SUBJECT: ADDENDUM NO. 2 TO THE BIDDING DOCUMENTS FOR

ROOF REPLACEMENT
ST. ELMO HIGH AND ELEMNTARY SCHOOL
ST. ELMO CUSD #202
ST. ELMO, FAYETTE COUNTY, ILLINOIS
HR # 150-0830

PARTIAL ROOF KEY PLAN AND DETAILS

PARTIAL JR/SR HIGH SCHOOL ROOF KEY PLAN

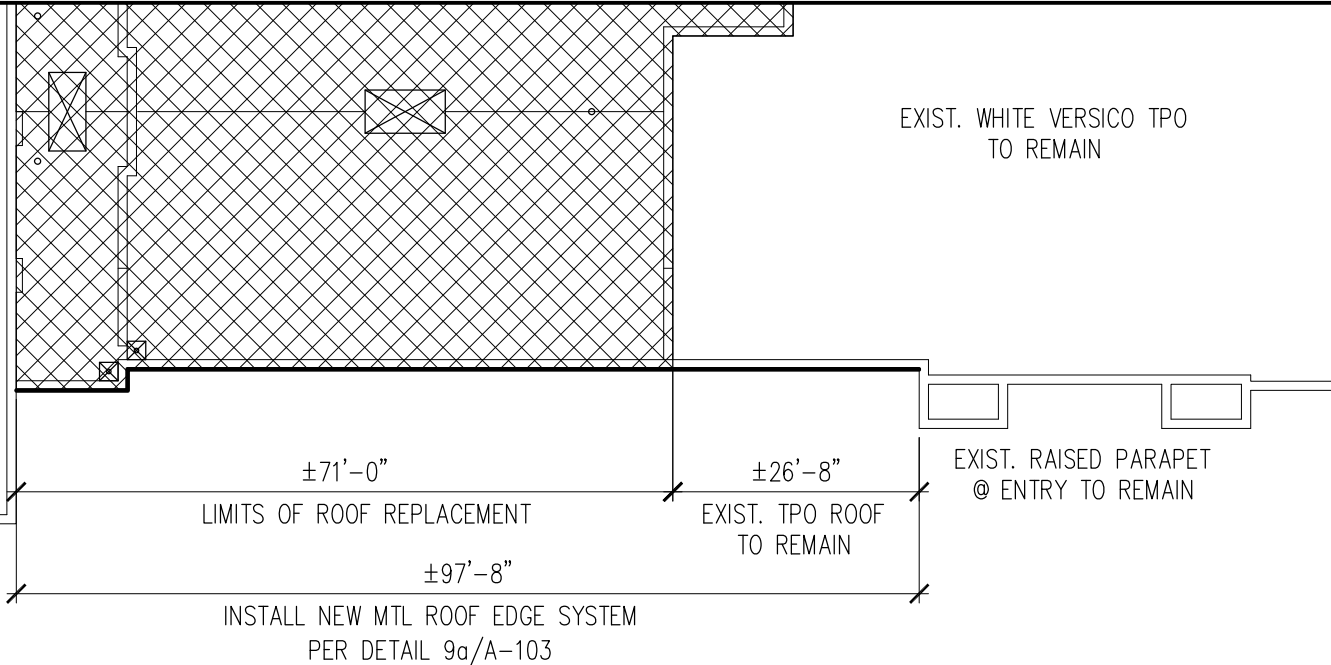
- A. Sheet A-101 JR/Sr High School Roof Plan
 - 1. **DELETE** Keyed Note #6 and **REPLACE** with the following: “Remove and dispose of existing membrane covered curb and cap to the existing deck. Infill deck opening with new 2x wood framing and 3/4 inch thick APA rated Structural I, grade CDX plywood roof sheathing to match elevation of existing deck. Install new roof system R1 per detail 2/A-101.”
 - 2. **ADD** Partial Roof Key Plan per Addendum Attachment A1. **DELETE** section tag 9/A-103 and **REPLACE** with section tag 9a/A-103 per Addendum Attachment A1.

PARAPET FLASHING DETAIL

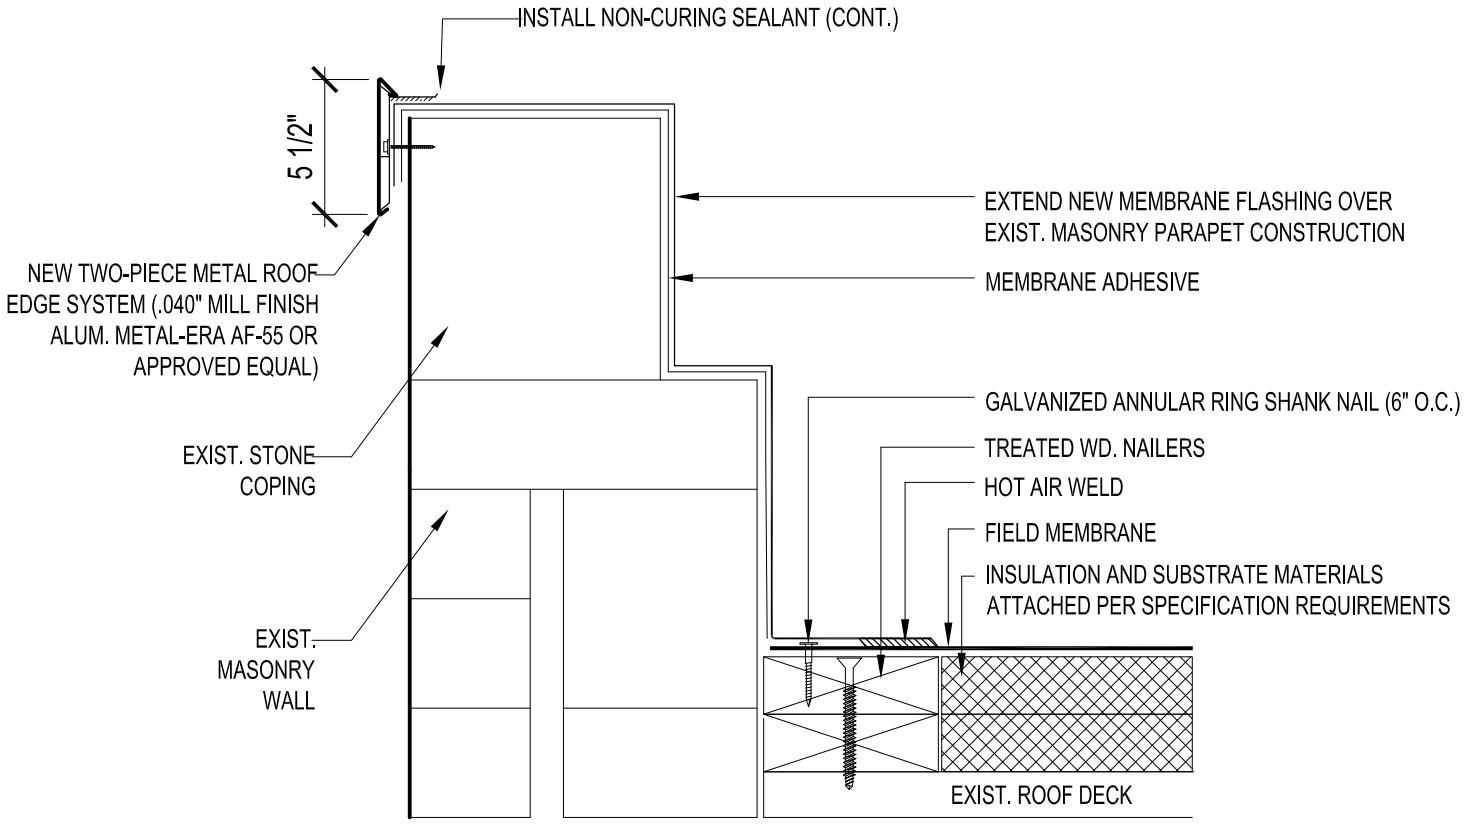
1. DELETE detail 9/A-103 and REPLACE with detail 9a/A-103 per Addendum Attachment A1.
